ATTACHMENT 2

WestConnex Stage 3 (M4-M5 Link) Concept Design Review Submission Facilitated by Beca Australia for Inner West Council July 2017

Attachment 1: WestConnex M4 – M5 Concept Design Plan Review – STRATEGIC ISSUES

Figure 8.1 Ventilation system (Source: M4 – M5 Link Concept Design Plan – May 2017)

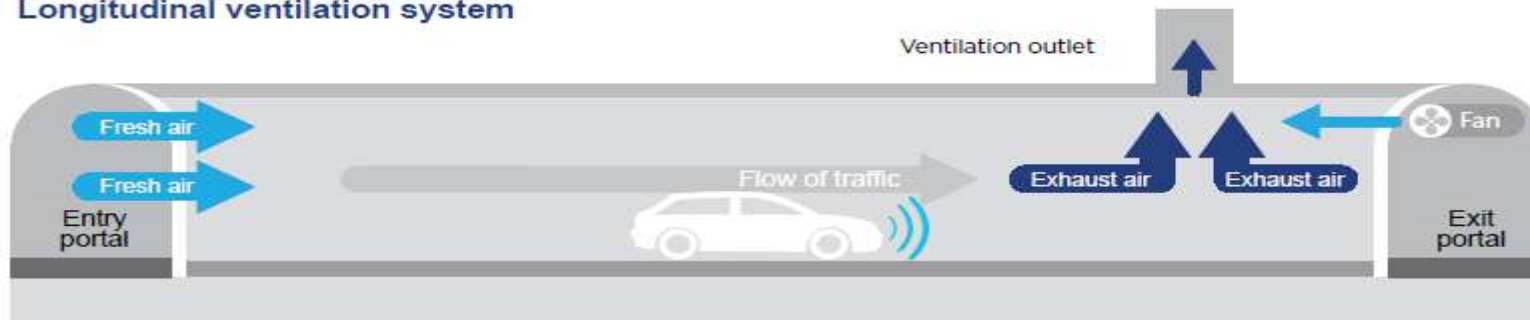
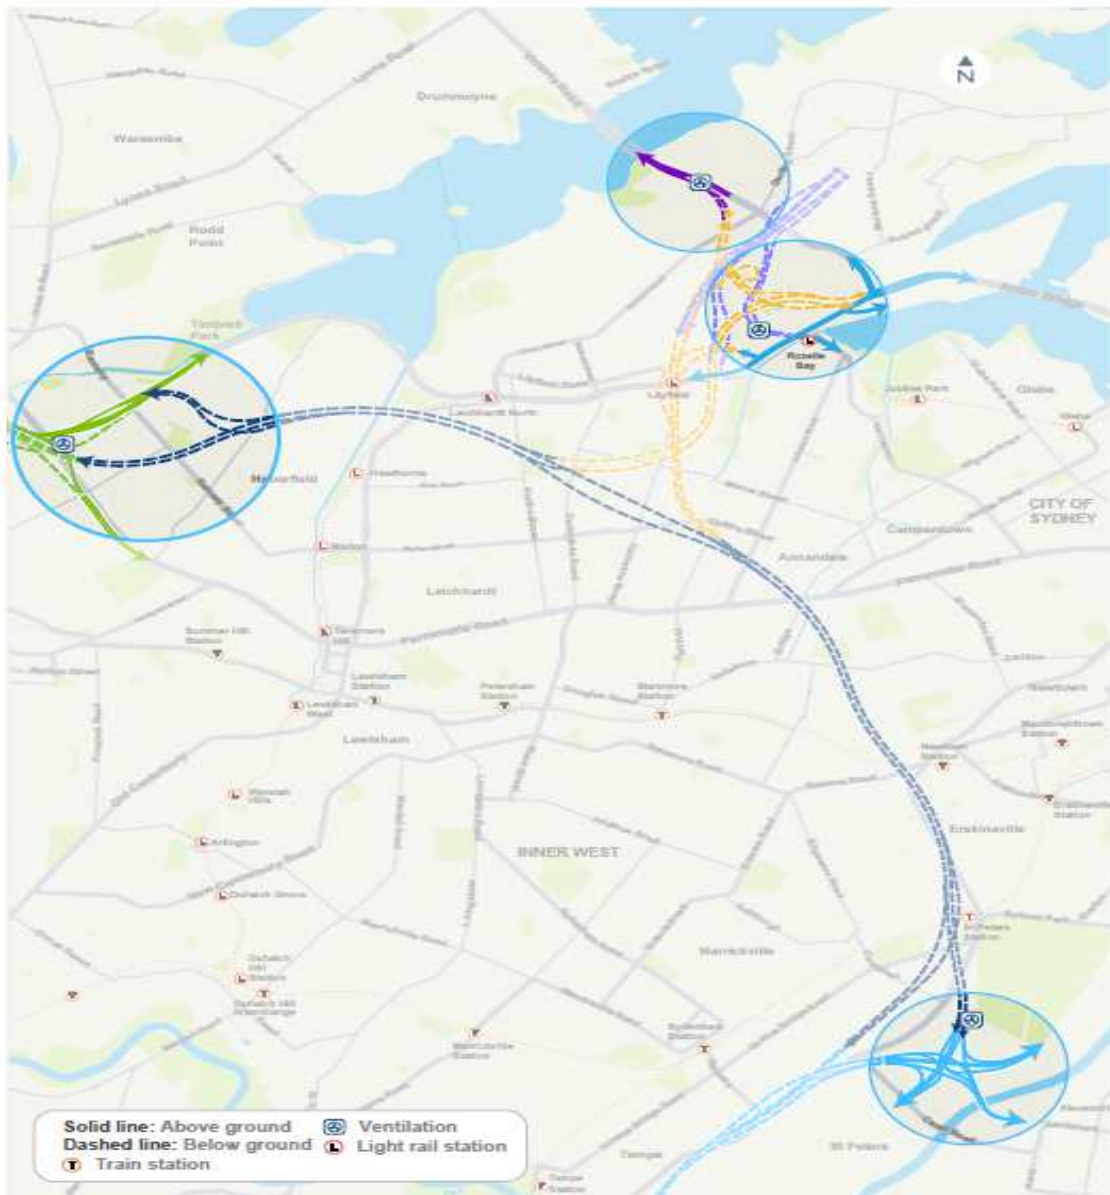
Item	Background information and source	Review comment
8	Other Key Issues - Ventilation	
8.5	<p>M4 – M5 Concept Plan - Section 7 The M4 – M5 Link (page 16): Ventilation facilities</p> <p>Tunnel ventilation is required to maintain in-tunnel air quality at a safe level for human health. It would also safely disperse the emissions created by cars travelling in the tunnel without negatively impacting the surrounding areas. Air from the tunnel will be dispersed to ensure no measurable air quality impacts at ground level. A key way of achieving this is to minimise emissions through portals, or tunnel exits. This means that the ventilation systems are designed to have zero portal emissions with all air being expelled through an elevated ventilation facility.</p> <p>The ventilation system proposed is called longitudinal ventilation and relies on single directional traffic flow and separate tunnels for each direction, with at least one outlet for each tunnel. The ventilation facility needs to be located close to the end of the tunnel, before the exit portal, to allow for air to be drawn into the portals against the flow of the traffic. This forced reverse flow is achieved by jet fans within the exit ramp and tunnel (refer to Figure 8.1).</p> <p>The location of ventilation facilities for the project has been influenced by the design of the already approved WestConnex New M4 and New M5 tunnels, both of which interface with the M4-M5 Link, as well as the length of the tunnels.</p> <p>In-tunnel ventilation modelling and assessment for the project is underway. The Environmental Impact Statement (EIS) will include a ventilation report and an assessment of a range of potential traffic and ventilation scenarios. It will detail how the ventilation design ensures that concentrations of air emissions meet state and national best practice for in-tunnel and ambient air quality. The following ventilation facilities are proposed (refer to Figure 8.2):</p> <ul style="list-style-type: none"> ▪ at Haberfield (the ventilation building is being constructed as part of the New M4 project and will be fitted out as part of the M4-M5 Link project); ▪ within the Rozelle Rail Yards; ▪ on Victoria Road, Rozelle (near the Iron Cove Bridge); and ▪ St Peters. 	<p>Refer to Items in Section 5 above.</p> <p>IWC expects that the requests formulated in the above items be followed-through and comprehensively addressed in the EIS to fully understand the visual and air quality impacts of proposed ventilation facilities.</p>
